Inspection of aileron weight and aileron c.g. and inspection of play (backlash) in aileron and flap control circuits to avoid flutter risk.

Glider model ASW 20, s/n 20 001 thru 20077 and 20 086.

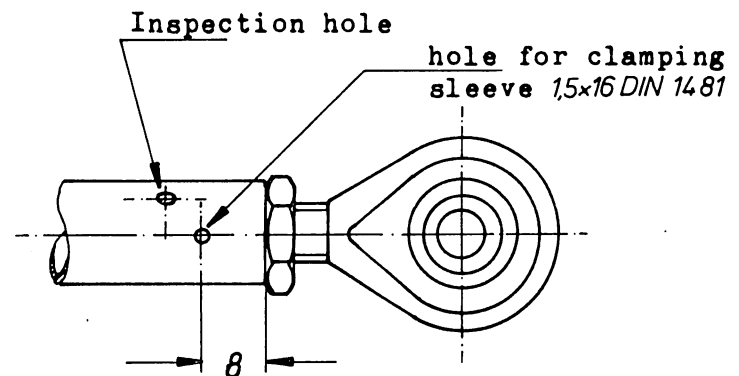
- a/ If new hollow tubular rivets including tools are available, the tubular rivet is drilled off.
 - b/ If procedure a/ is impossible, the fairing of the aileron actuator is split off carefully and the whole metal fittings are unscrewed from the ailerons.

The weight of each aileron is determined (don't forget the fairing which is split off) and compared to the tolerances given in the Manuals. If according to procedure b/ the metal fittings were removed, 0.07 kg must be added to the determined weight.

Determination of tailheavy moment of controls by balancing
on a cutting edge done twice (triangular strip)

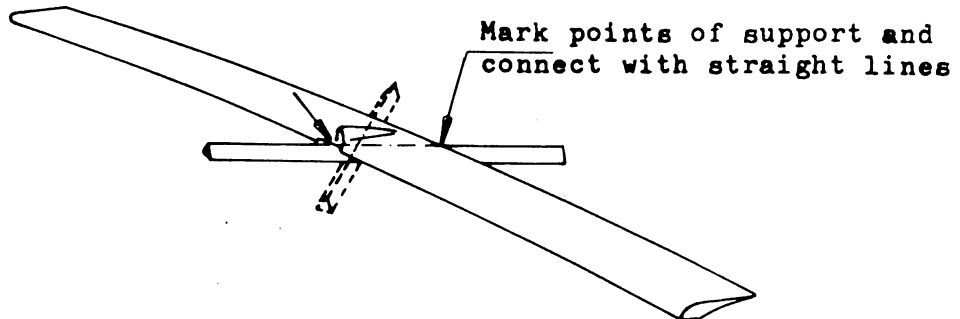
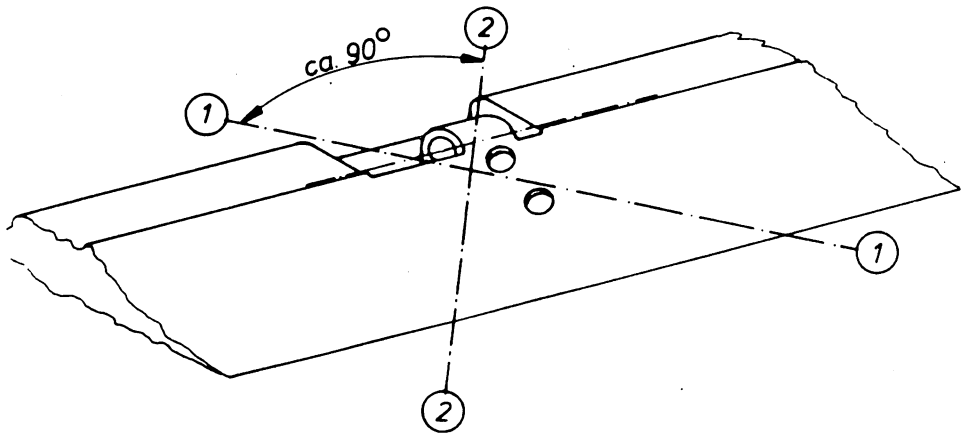
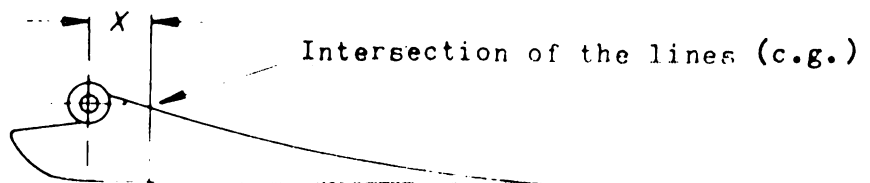
Diverging from the sketch in the Manuals the c.g. of the ailerons is balanced according to the sketch on sheet 5 of this Technical Note. The weight of the aileron (if fittings have been removed, without their 0.07 kg) as determined multiplied by the distance from the c.g. to the hingeline is the tailheavy moment of the aileron. If the actuator fitting was removed, 0.15cmkg must be added. This total moment must not be greater than tolerated by the Manuals.

The connecting lines of the points of support ① - ① and ② - ② intersect in the c.g.

X = Distance from the c.g. to the center of the hingeline.

Weight (kg) · X (cm) = Moment (cmkg)
